Cabarrus County Planning and Zoning Commission
Tuesday, November 9, 2021 @ 6:30 p.m.
Board of Commissioners Meeting Room
Cabarrus County Governmental Center

Planning and Zoning Commission Minutes
November 9, 2021

NC 102 Solar Facility Update Report

Photos of area from October 29, 2021

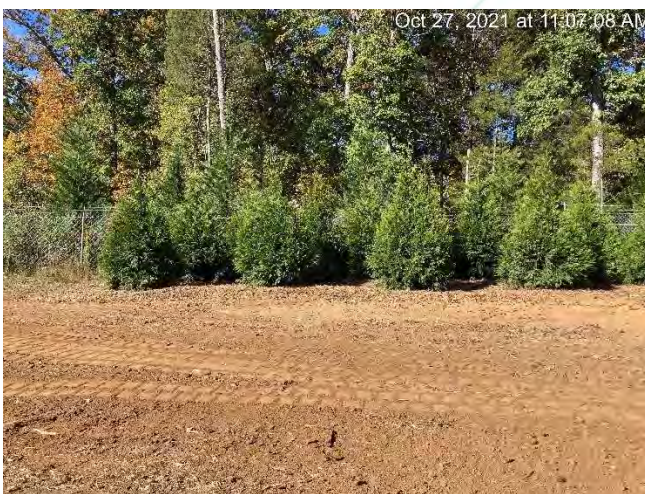
Comment #2: This area needs to be planted a minimum of 60 feet on either side of the corner post. The Committee is willing to allow additional Leyland Cypress to be used in this area to create an evergreen buffer for the residential property. Plantings should be installed interior to the fence on the solar farm side to allow appropriate room for growth.

Stream/Wetland and Floodplain Restoration Areas – Green areas shown on plan below

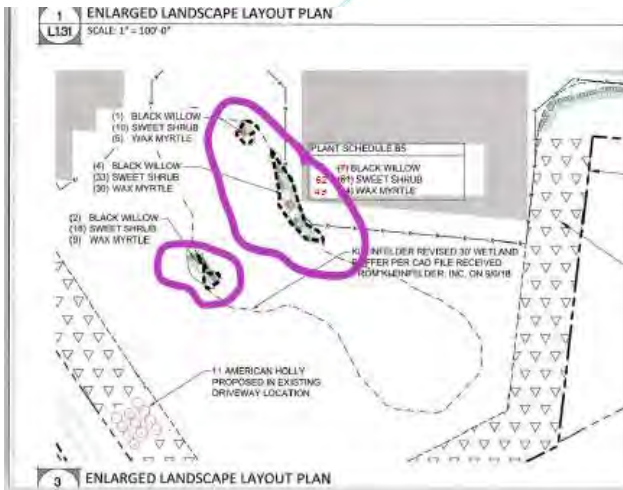
Comment #3: Additional evidence needs to be provided that the pine seedlings were planted in accordance with the planting schedule throughout the entire restoration area. Plantings should be flagged, and a series of photos provided for the green areas shown on the plan above. The Committee would like for county staff members to visit the site once the plants are flagged in all the stream/floodplain restoration areas to confirm planting at the proper density and per the approved CCSWCD Restoration Plan.

Status: Cabarrus SWCD Staff confirmed during the site visit that the pine seedlings have generally been installed per the remediation plan.

2. B8-J Elective Understory Tree Buffer

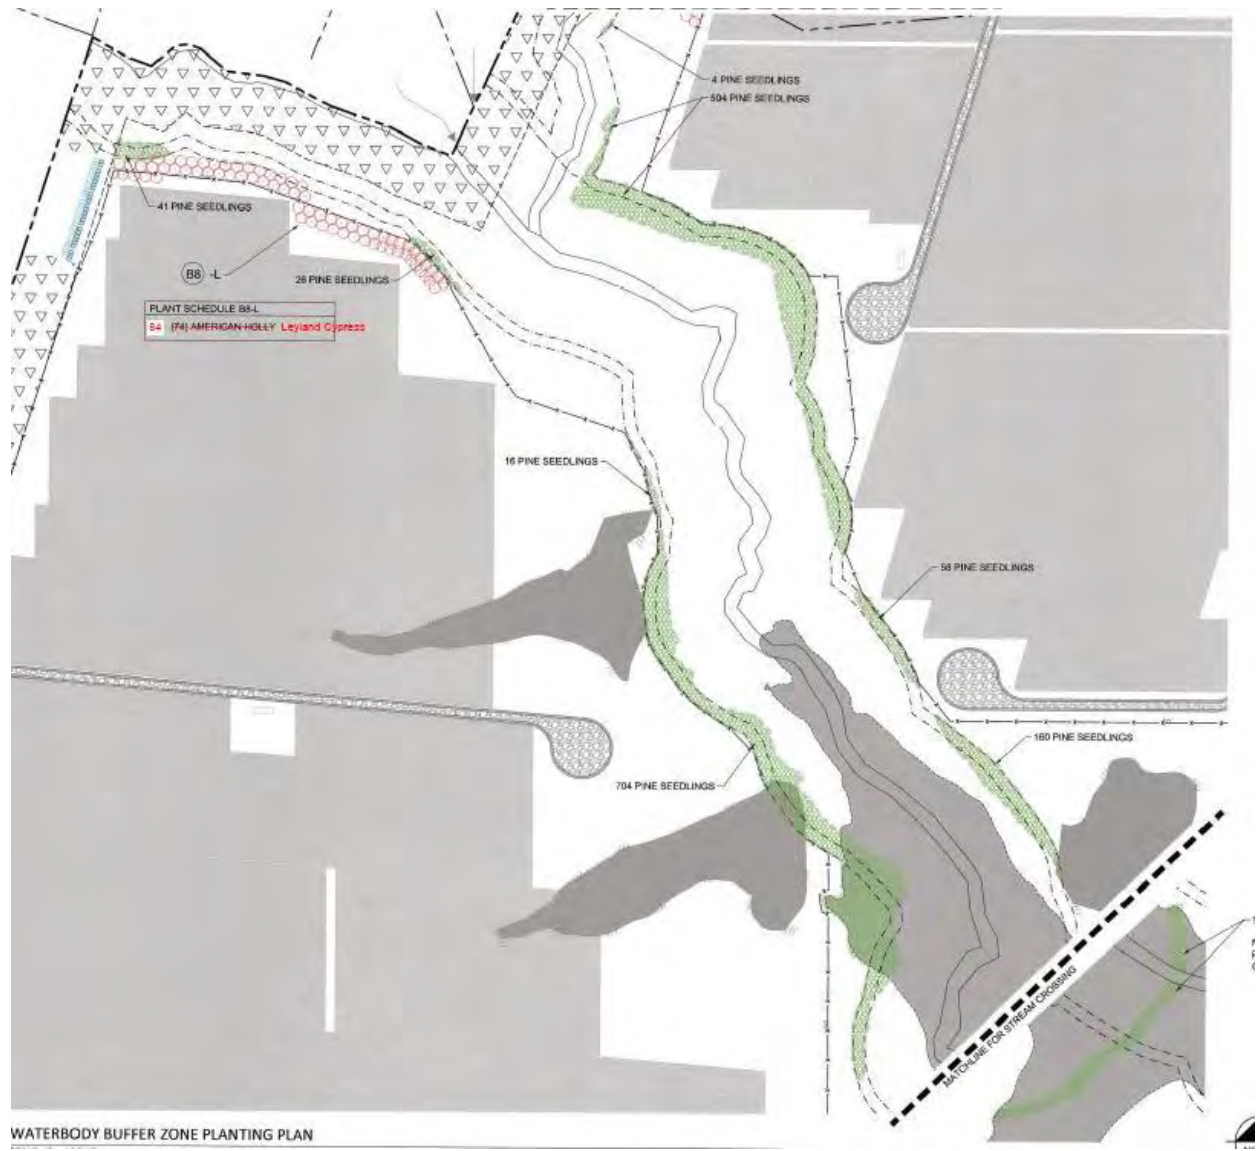
Left side of access road where house is adjacent to fence. This area needs to be planted a minimum of 60 feet on either side of the corner post. The Committee is willing to allow additional Leyland Cypress to be used in this area to create an evergreen buffer for the residential property. Plantings should be installed interior to the fence on the solar farm side to allow appropriate room for growth.

NC 102 will plant 32 additional Leyland Cypress at a height of 8 to 10 feet along the interior of the fence line. To be completed week of June 7, 2021.

Figure 1A – SB11 Suggested design considerations (planform)

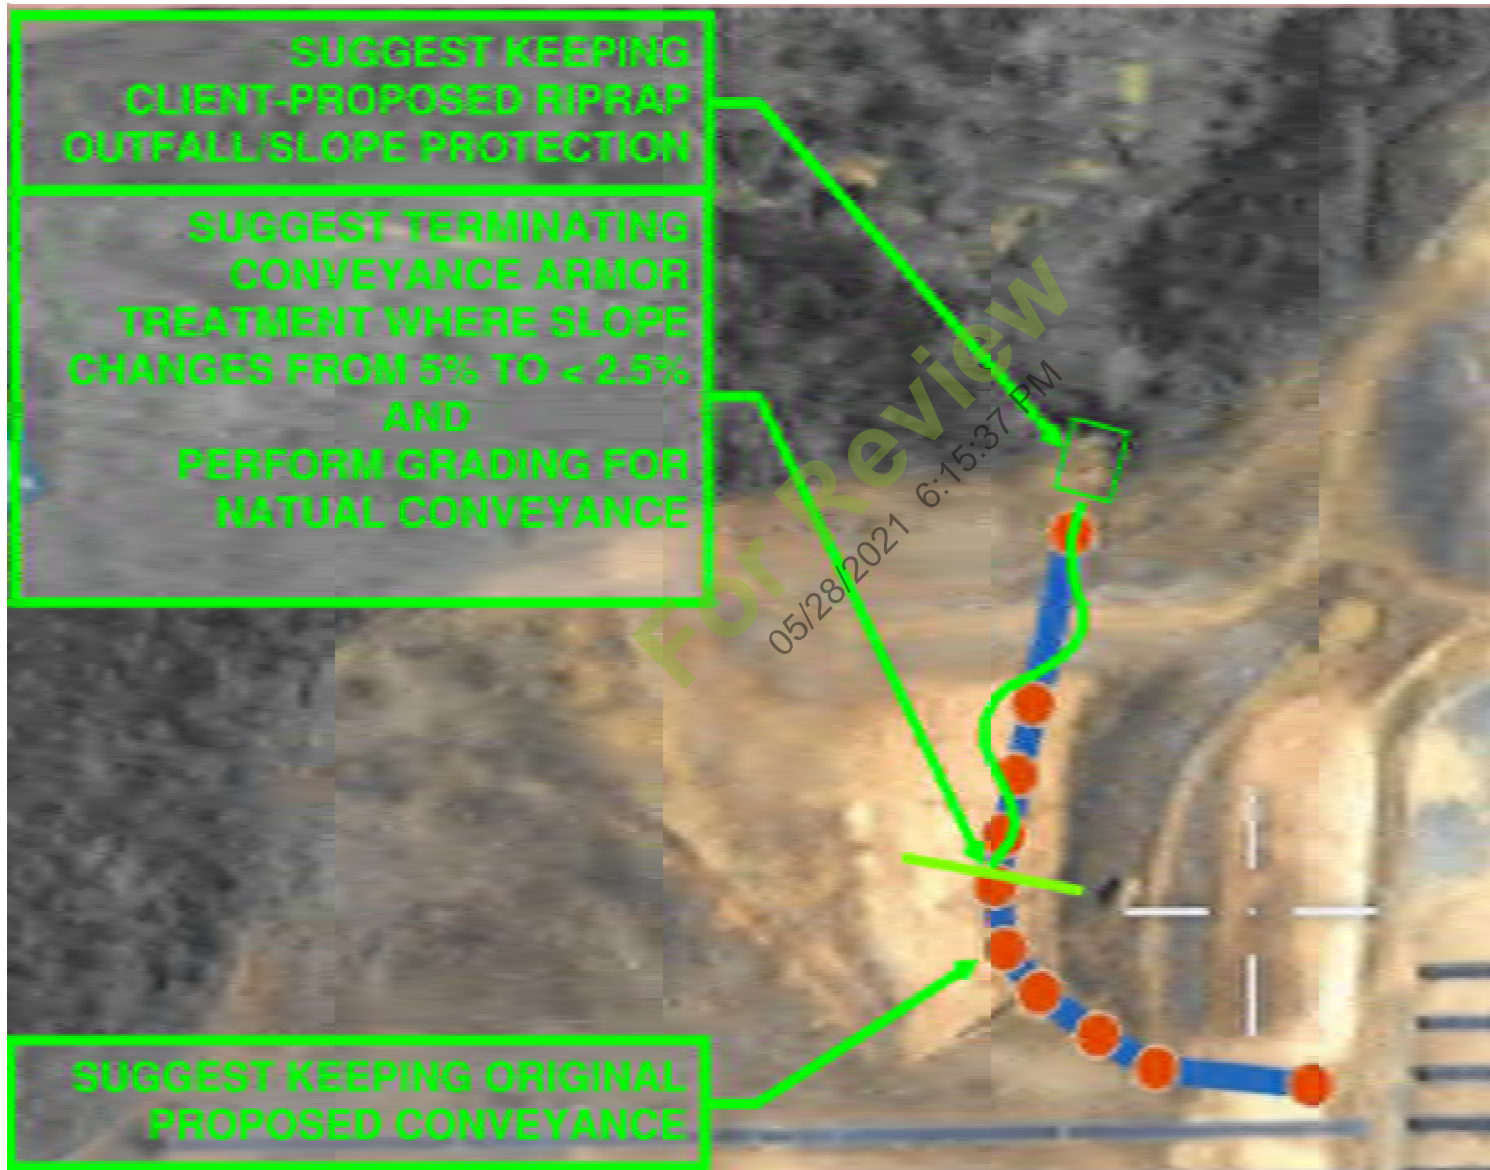
Suggested revisions to the currently proposed modified conveyance include the above suggestions (modify section, modify extent of placement, introduce natural channel functions) and the below schematic (Figures 1A, 1B, and 2). If elected, some or all of these suggestions could be implemented in the field, possibly reducing stone/earthwork costs.
